Response to Referee #2 of our manuscript entitled
Coastal Impacts of Storm Gloria (January 2020) over the Northwestern Mediterranean
[nhess-2020-75] submitted to *Natural Hazards and Earth System Sciences.*

Angel Amores, Marta Marcos, Diego S. Carrió, and Lluís Gómez-Pujol

May 21, 2020

Figure 1: Sea level time series at Barcelona tide gauge (upper panel) and zoom of the most recent period (lower panel)

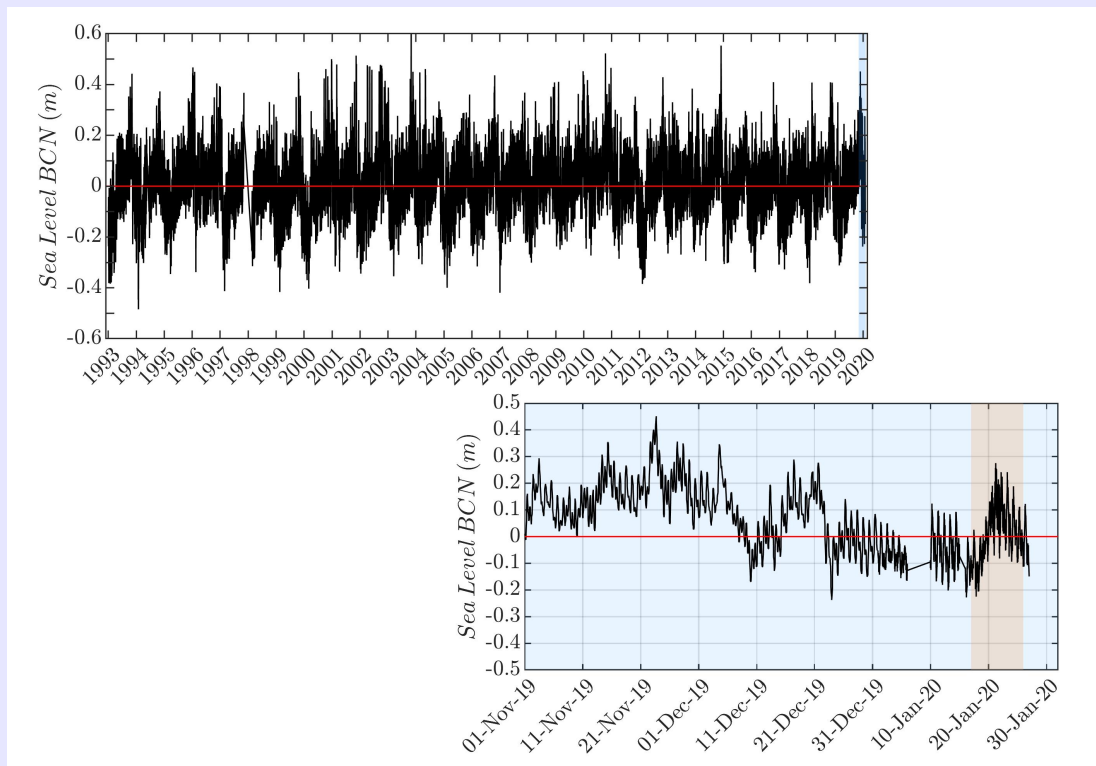
1.Role of neglected processes? 3D Mediterranean circulation induce seasonal water level fluctuations of several centimeters to tens centimeters [Bouffard and Pascual; Larnicol et al., 1995]. For example, Larnicol et al. [1995] indicate variations of +/- 10 cm at the scale of the whole Mediterranean Sea and of each of the two basins. Such fluctuation is far to be negligible for flood issues in micro-tidal areas as the study sites. A bit of discussion on this water level contribution during the Gloria storm would be useful and could reinforce the confidence in the results, if, for instance, this contribution contributed for almost zero during Gloria storm.

In addition, all the modeling experiment seem to neglect the tide. The authors should make more explicit that they neglect the tide and discuss the implications on the results for the flood investigations (Ebro Delta and Balearic rocky cliff). Indeed, for instance, the maximum tidal range seems far to be negligible (0.85 m in Barcelona after `http://www.portdebarcelona.cat/en/web/el-port/101#2`) in front of the Gloria storm surge. But what was the tide during Gloria storm?

Author's response: Seasonal sea level changes in the Mediterranean Sea range between 4 and 8 cm for the annual and 2 and 4 cm for the semi-annual signals, on average [*Marcos and Tsimplis*, 2007], in agreement with the magnitude pointed out by the reviewer. We have explored this baroclinic signal as illustrated in the figure below, corresponding to the tide gauge record in Barcelona. The time series has been demeaned and detrended. According to *Marcos and Tsimplis* [2007], in the western Mediterranean basin the sea level seasonal cycle peaks between September-November, and decreases afterwards. This is observed in the figure (lower panel). This panel also shows that mean sea level during Storm Gloria varies around the zero, which corresponds to the averaged mean sea level during the tide gauge period. Therefore, we conclude that seasonal mean sea level does not add any further effect that amplified or reduced the impacts of the storm.

Author's response: There seems to be an error in the tidal range at the site referenced by the reviewer. The tides in Barcelona, as in most of the Mediterranean Sea are much smaller. This is observed in the figure above of the previous response. Also, please check

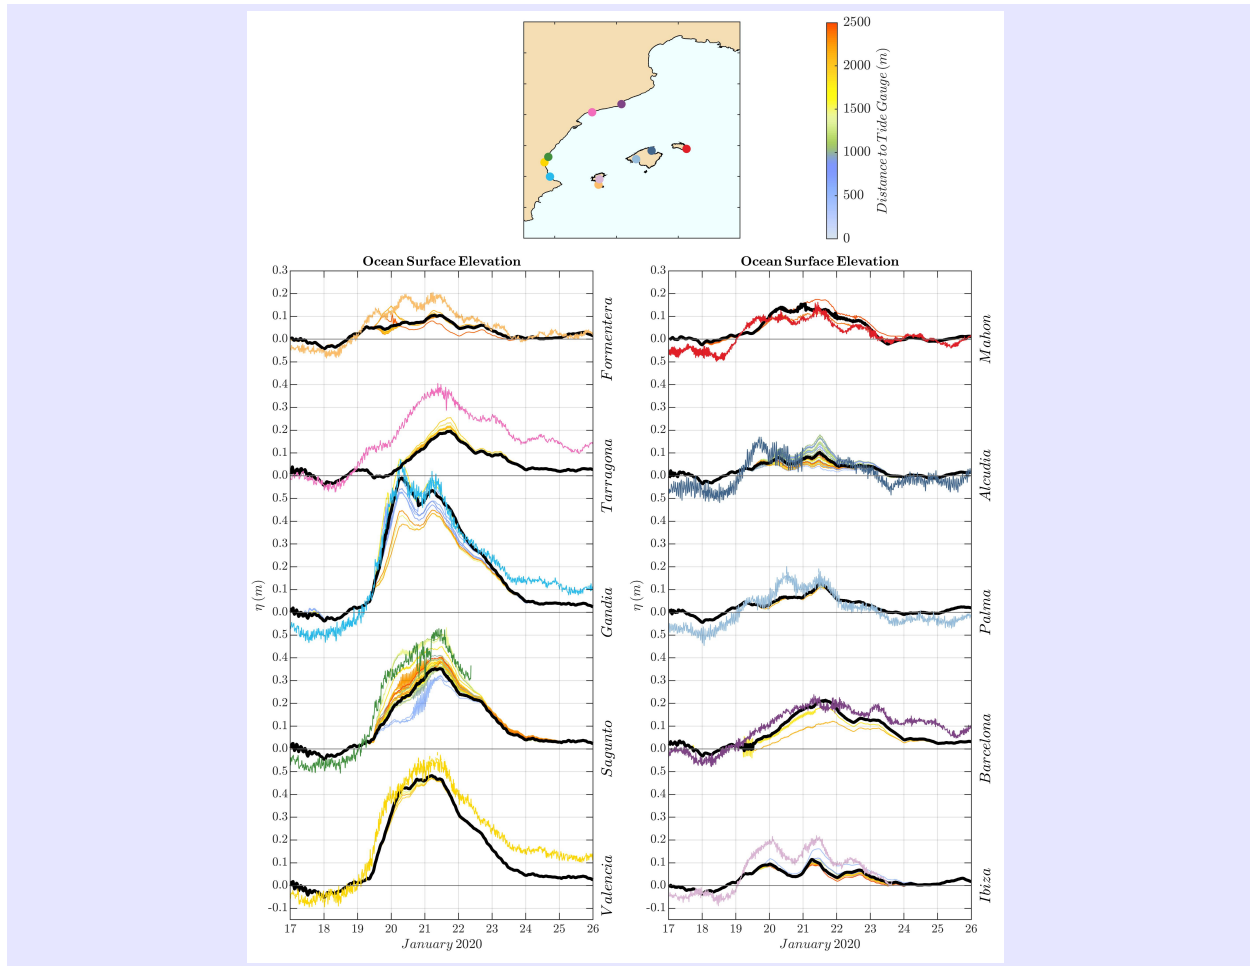
Second, and more importantly, I have some doubts with the method which consists in comparing the water level model outputs in the 5km radius to the local tide gauge measurements. Indeed, depending on the grid points, some points may include a part of the wave setup (probably less

than the reality due to the too coarse resolution of the model, except close to the Ebro delta area), others not. As illustrated in Figure 4, there is a strong variability in the model outputs in the 5km radius, which makes not fully convincing the conclusion of a model providing satisfactory prediction compared to the tide gauge measurements. I would suggest at least to add the model outputs of the nearest point to the tide gauge (simulation #1 and #2). In theory (if the grid resolution is high enough to capture the wave setup), the tide gauge measurements should be comprised more or less between the results of simulation #1 and #2, for the nearest point. If there are discrepancies, the authors could discuss the location and resolution of the model close to the tide-gauge (with maps) and also discuss the local knowledge of wave setup contribution to the tide gauge measurements. To contribute to provide a clearer validation and keep the 5km radius, another idea could be to plot all the model outputs for simulations #1 (first) but with a colorscale (on the time series of model outputs) indicating the distance of the model outputs to the tide gauge, and put in thick line the closest point (together with the tide gauge observation of course). The same figure could be done with the simulations #2 (together with the tide gauge observation of course). Of course, the authors are free to follow other ideas, as long as it makes the validation clearer by at least showing results on the closest point. I think this an important issue. Refining the validation could also help identifying to which extend the seasonal water level fluctuations induced by 3D circulations are negligible or not during the Gloria storm.

Author's response: We have explored different options to meet the reviewer requirements and we decided that the best one is to represent the time series of the modelled points within a radius of 2.5 km to the tide gauge location and indicating the closest grid point with a thicker line (see the new Figure 4).

We also produced alternative figures following reviewer's recommendations, including a different color lines depending of the distance for grid point (see the figure below). This format is, in our opinion, less clear and hinders its interpretation. In addition, we also produced a figure merging the results of simulations #1 and #2 (not shown here) but again it looked too messy. We hope that the reviewer's concern about the ability of the model in resolving the wave setup was satisfied with the answer to the question #2. The results showed essentially the same conclusions as in our example for Gandia tide gauge discussed above.

We hope that the new Figure 4 is more satisfactory for the reviewer.
